ADDENDUM NO.: 1

DATE: September 4, 2026
PROJECT: Mary G. Montgomery Gymnasium
DCM #: 2026145
FPN #: 25-10
WSM #: 25-138

OWNER: Mobile County Public School Systems
ARCHITECT: Ward Scott Morris Architecture, Inc.

1 FINISH SCHEDULE AND LEGEND
N.T.S.

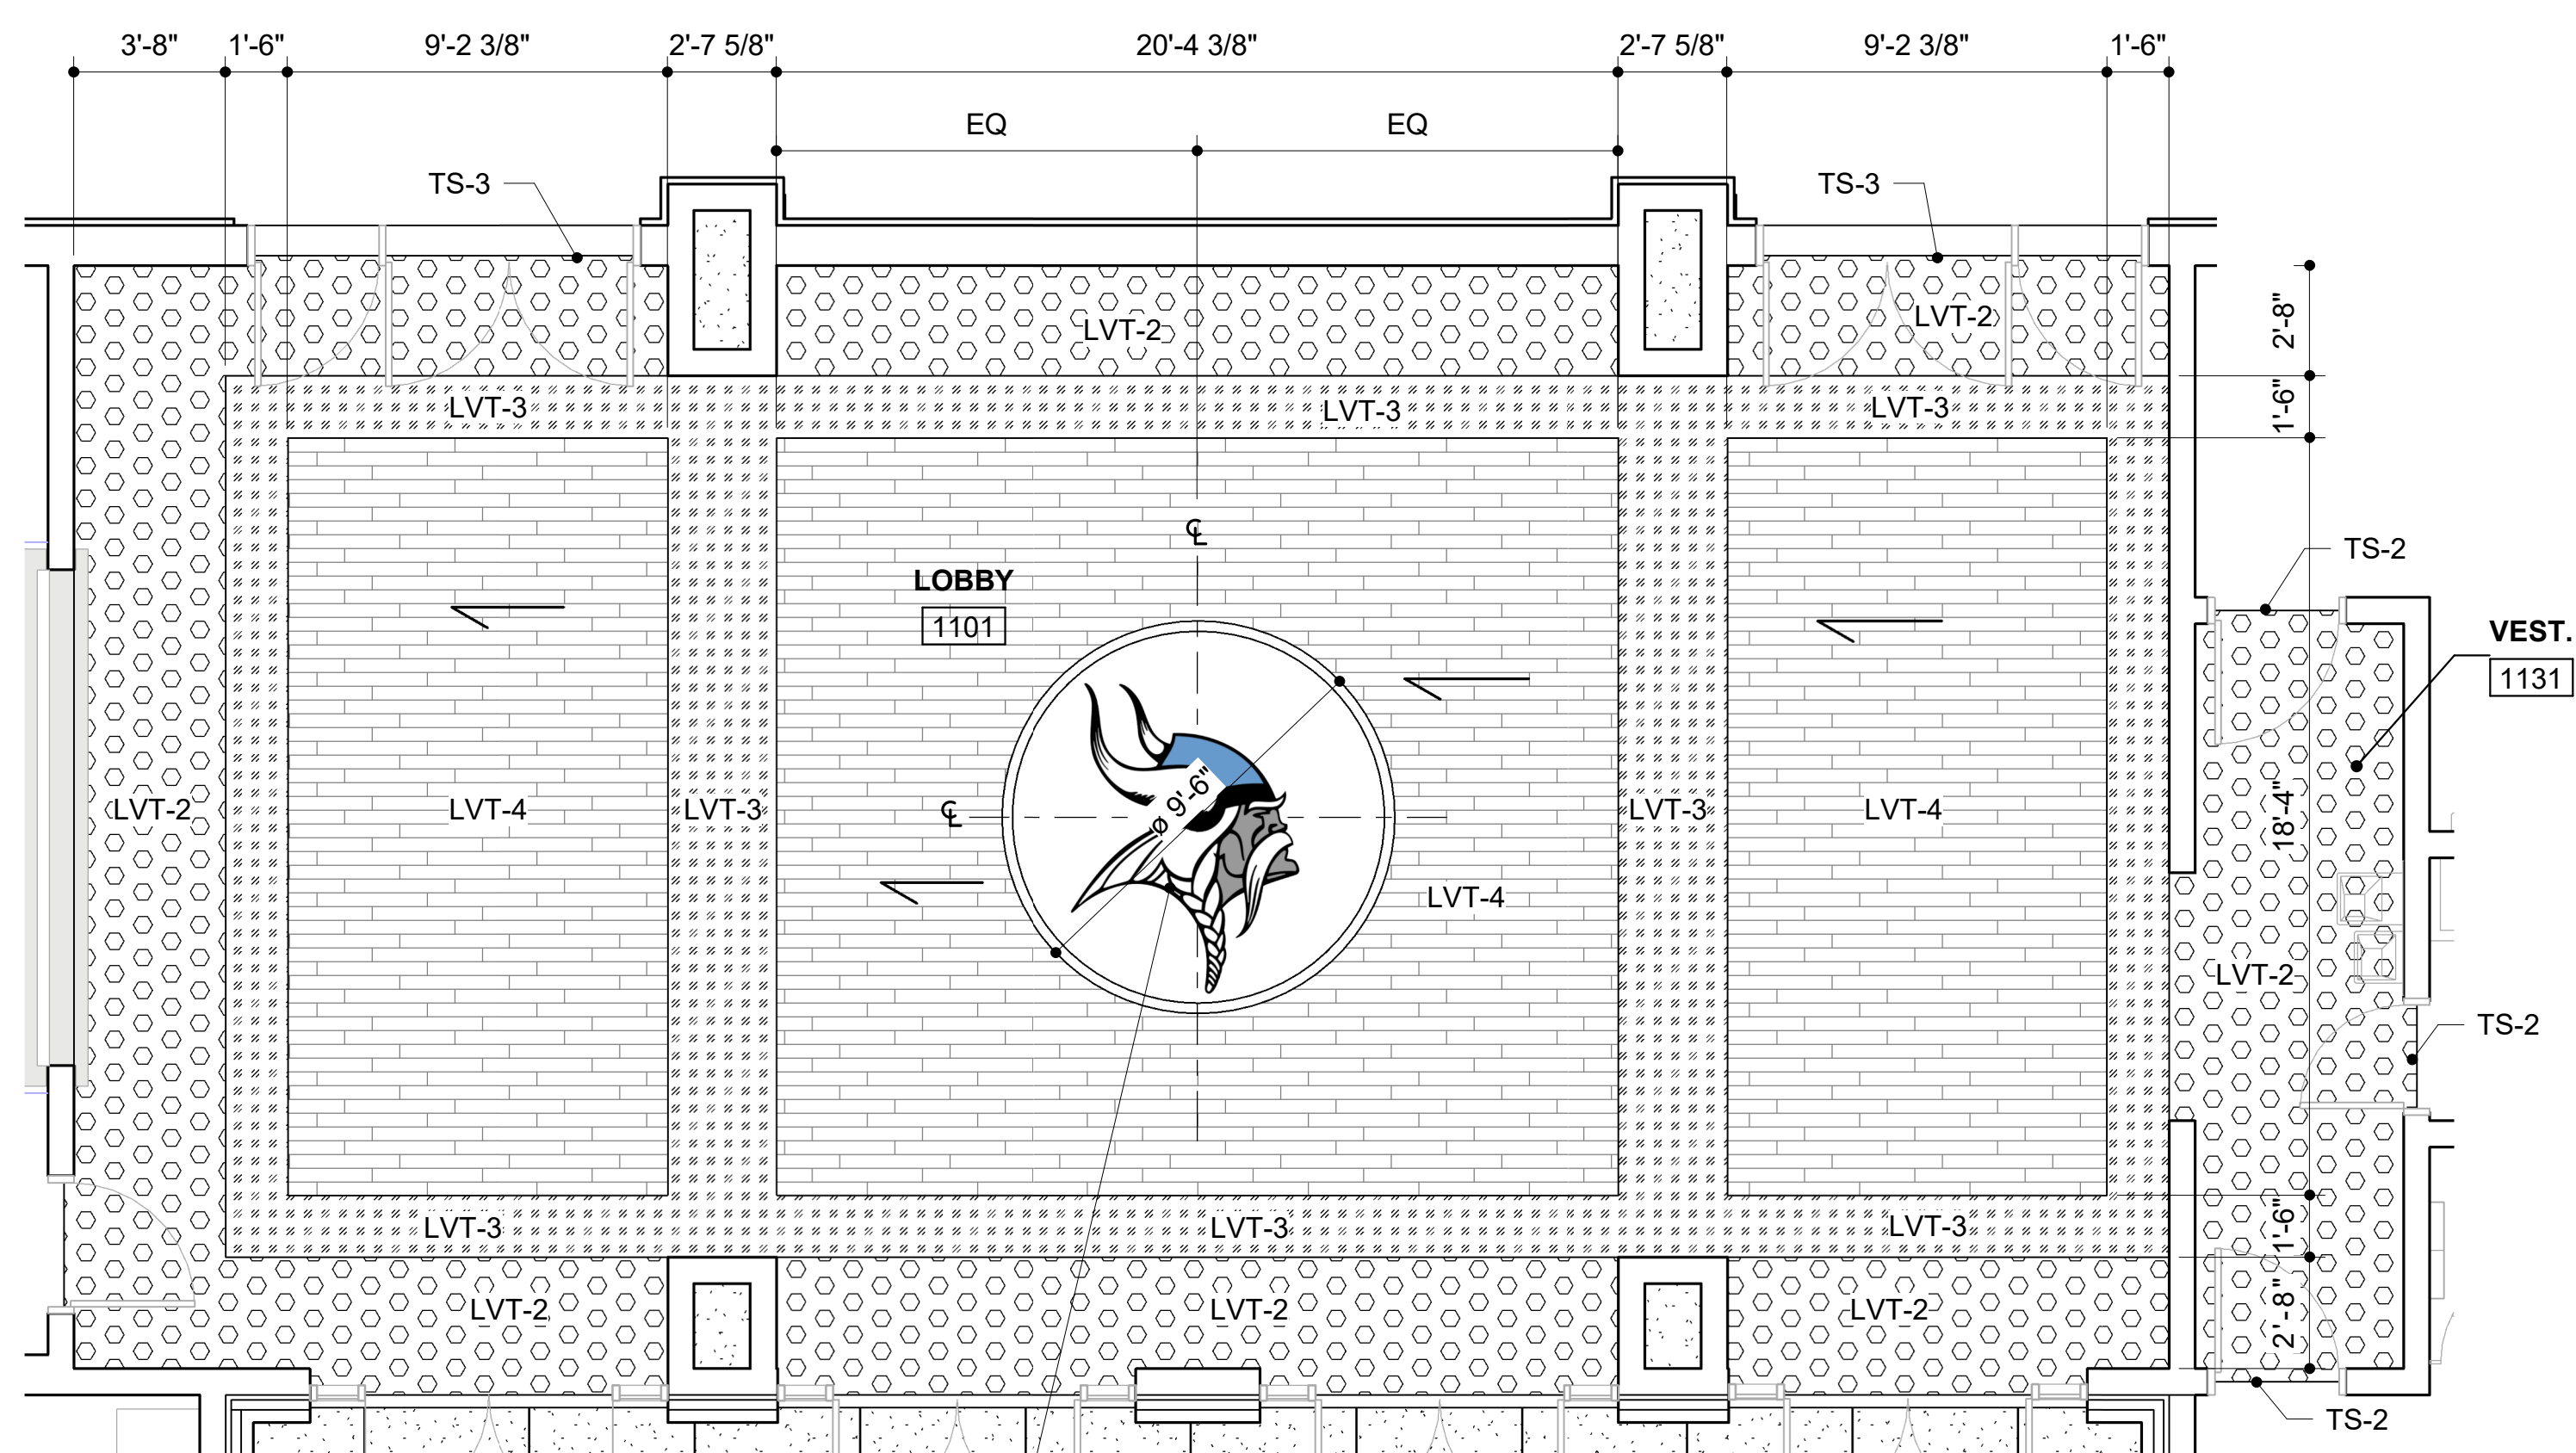
RSF-1	RESINOUS FLOORING WITH 6" COVE BASE SHERWIN WILLIAMS RESUFLOR DECO SMALL FLAKE 1/8" SB COLOR: TUNGSTEN 1/8" WEARING SURFACE: STANDARD AT ALL SEE SPECS FOR MORE INFO. SEE 2/A602 FOR BASE DETAIL.	TRANSITION STRIPS	GWT-2 GLAZED ACCENT WALL TILE TRINITY SURFACES COLLECTION: WREN COLOR: CAMELIA FINISH: GLOSSY SIZE: 2' X 10" THICKNESS: 8MM GROUT COLOR: LATICRETE 89 SMOKE GREY	SS-1 SOLID SURFACE CORIAN COLOR: EVEREST LOCATION: COUNTERTOPS	1. SEE 1/A401 FOR DECORATIVE WALL TILE PATTERN. TILE PATTERN TO BE ON SINK WALL ONLY. ALL OTHER WALLS TO HAVE PWT-1 WAINSCOT TO 6'-6" A.F.F. - SEE INTERIOR ELEVATIONS. 2. SEE 2/A401 FOR TYPICAL WALL PAINT PATTERN. SEE FLOOR PATTERN/FINISH PLAN ON SHEET A601 FOR TYPICAL PAINT PATTERN LOCATIONS. 3. SEE FLOOR PATTERN/FINISH PLAN ON SHEET A601 FOR ACCENT PAINT LOCATIONS. 4. PROVIDE 9'-6" DIAMETER LVT LOGO CUT BY MANUFACTURER. SEE SHEET A601 FOR FLOOR LOGO DETAIL AND LOCATION. 5. MILLWORK FINISHES TO BE PL-1 ON VERTICAL/CABINET SURFACES AND SS-1 ON COUNTERTOP WITH EASED EDGE AND 4" BACK/SIDE SPLASHES. SEE INTERIOR ELEVATIONS AND SECTIONS. 6. PROVIDE LOGO GRAPHIC ON WALL PADs AS SHOWN ON ELEVATION 1/A402 & 2/A403 - TO BE APPROVED BY DESIGNER. 7. CONCESSION WINDOW TRANSACTION COUNTERTOP TO BE SS-1 WITH SS-1 SKIRT ON LOBBY SIDE AND PL-1 BASE CABINET ON CONCESSIONS SIDE. SEE INTERIOR ELEVATIONS. 8. PROVIDE 24" DEEP ADJUSTABLE PLASTIC LAMINATE (PL-1) SHELVING ON METAL STANDARDS. 9. SEE 1/A602 FOR ATHLETIC WOOD FLOORING DETAIL. 10. GYM STRUCTURE TO BE PAINTED PNT-1. SEE INTERIOR ELEVATIONS. 11. SEE ELEVATIONS AND FLOOR PATTERN PLAN FOR WALL PAD LOCATIONS. 12. PROVIDE WALL GRAPHICS - SEE ALLOWANCE SECTION IN PROJECT MANUAL. 13. SEE 3/A401 FOR TYPICAL COACHES' TLT TILE PATTERN. 14. SEE SHEET A/321 FOR SOLID SURFACE TOP CAP DETAILS. 15. PROVIDE PWT-1 WAINSCOT TO 6'-6" A.F.F. ON NORTH, SOUTH, AND WEST WALL. PROVIDE DECORATIVE WALL TILE PATTERN ON EAST WALL ONLY. PROVIDE PWT-1 TO FULL HEIGHT AT SHOWER ONLY. SEE INTERIOR ELEVATIONS. 16. PROVIDE RB-1 AT CPT-1 LOCATIONS ONLY - SEE 1/A601.

1 FLOOR PATTERN AND FINISH PLAN
1/8" = 1'-0"

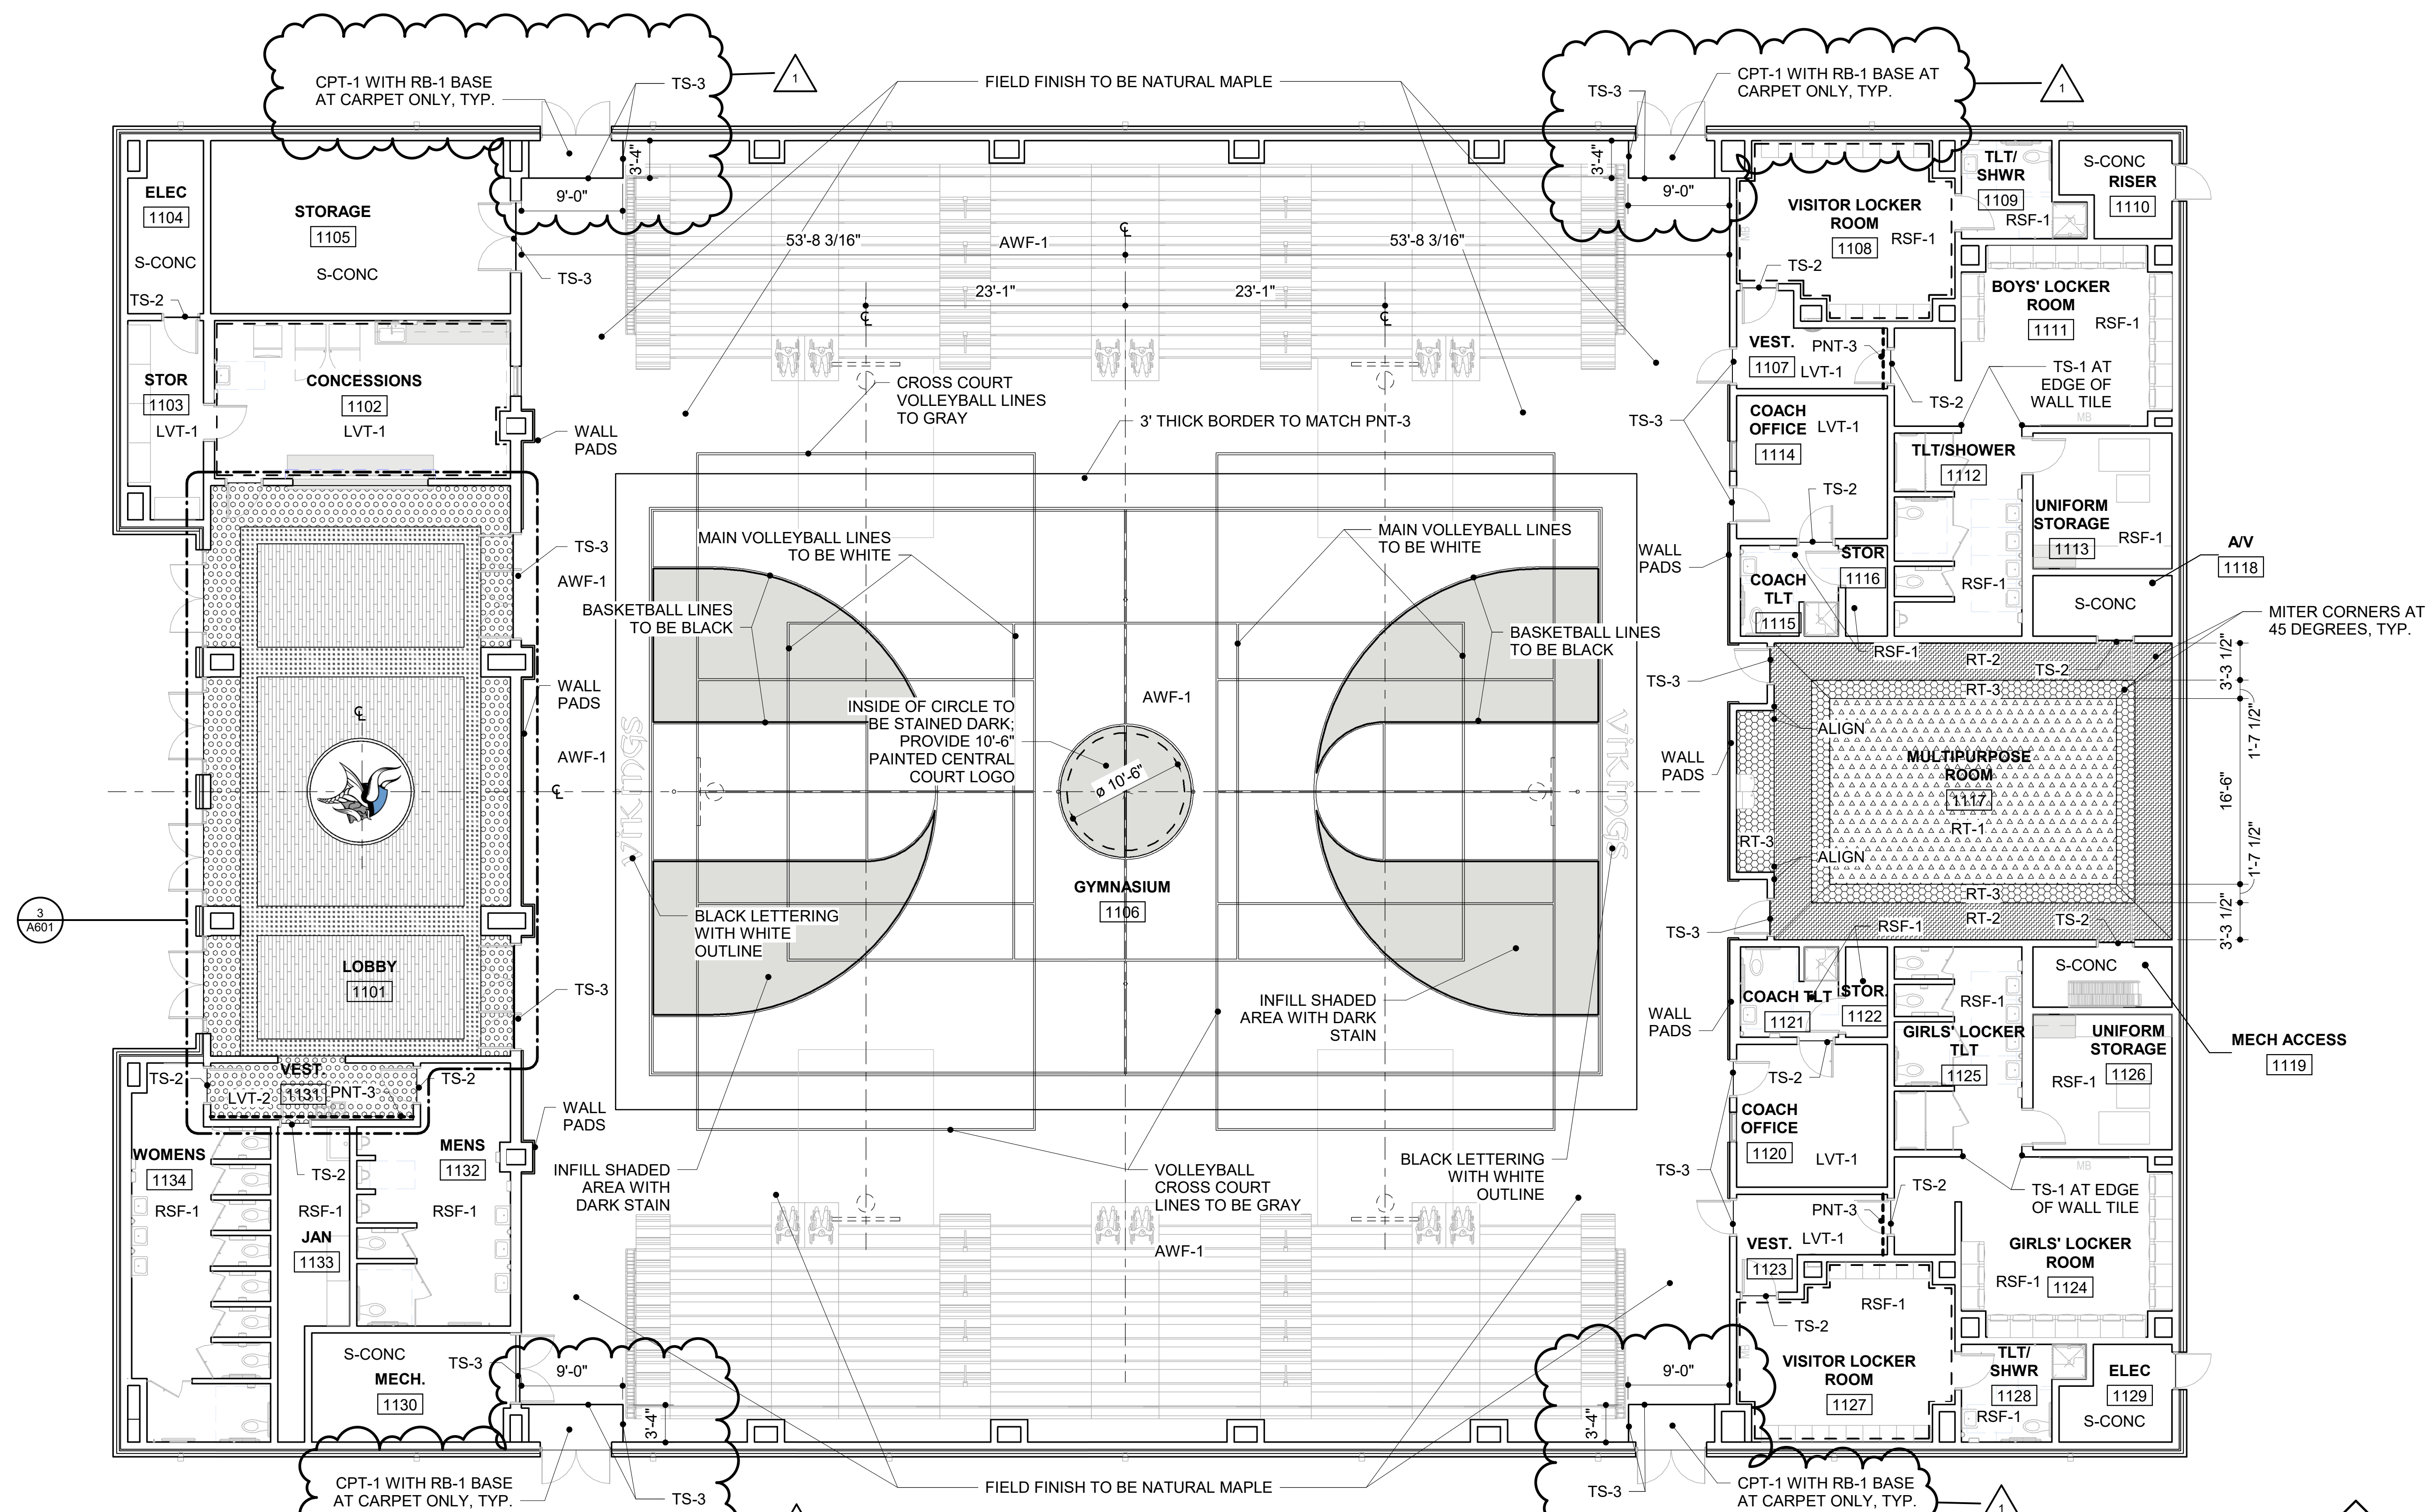
CPT-1 WALK OFF CARPET
TARKETT
STYLE: ASSERTIVE RIB 04838
COLOR: 26201 CHROMIUM

③ AWF TO WALK-OFF FLOORING DETAIL
6" = 1'-0"

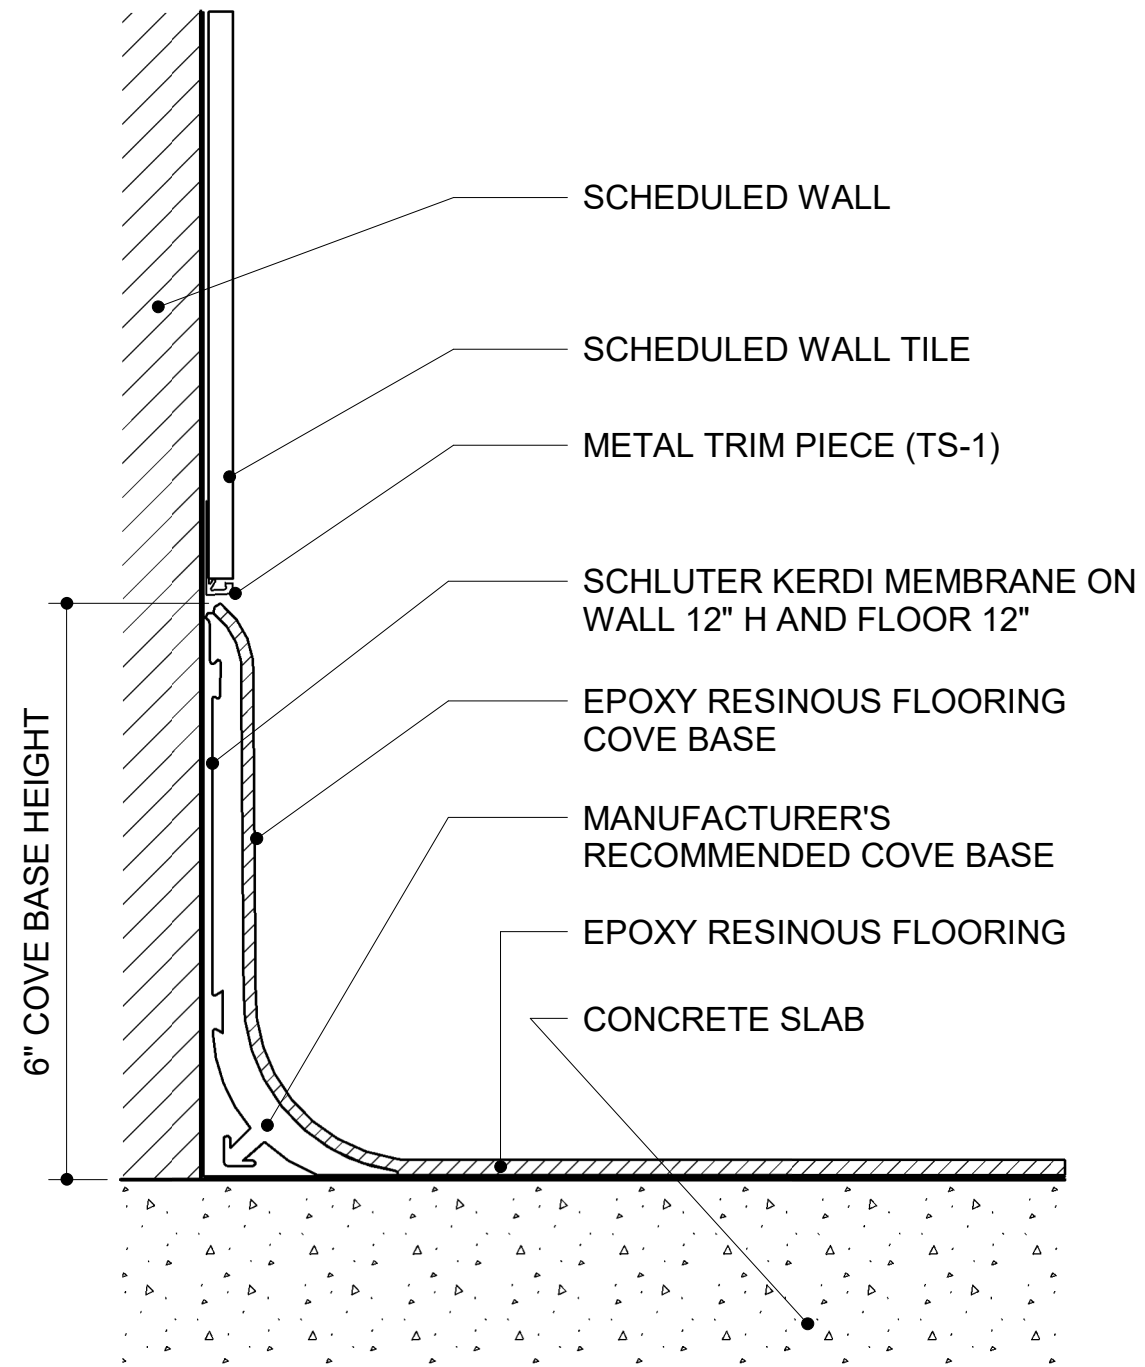
- A. Add the following division section to the specification manual:
 - 1. SECTION 096813 - TILE CARPETING
- B. Revise SECTION 096466 - WOOD ATHLETIC FLOORING to reflect the following:
 - 1. PART 2 – PRODUCTS
 - 2.4 FLOORING MATERIALS
 - B. Random Length Strip Flooring
 - 1. Grade: MFMA-RL **Second and Better Grade.**
 - a. Exception: For areas under stacked portion of telescoping bleachers that are fully concealed from view, Third and Better Grade is acceptable.
 - 2. Cut: Mixed Grain.
 - 3. Thickness: 25/32 inch (20 mm).
 - 4. Face Width: **2-1/2 inches (63.5 mm)** or 2-1/4 inches (57 mm)
- C. Revise SECTION 096466 - WOOD ATHLETIC FLOORING to reflect the following:
 - 1. PART 2 – PRODUCTS
 - 2.6 ACCESSORIES
 - E. Threshold cover plate / Floor-edge Expansion Joint Cover:
 - 1. Provide at transitions over wood flooring expansion gap to adjacent finish floor surfaces

2. Equal to: **Western Weatherseal CP304BST (6")**

- a. Pre-drilled countersunk holes, attached with free edge on wood floor surface side.
- b. Coordinate in field for edge alignment with adjacent wall base or other finished as directed.
- c. Architect selection from mfg full color range.)
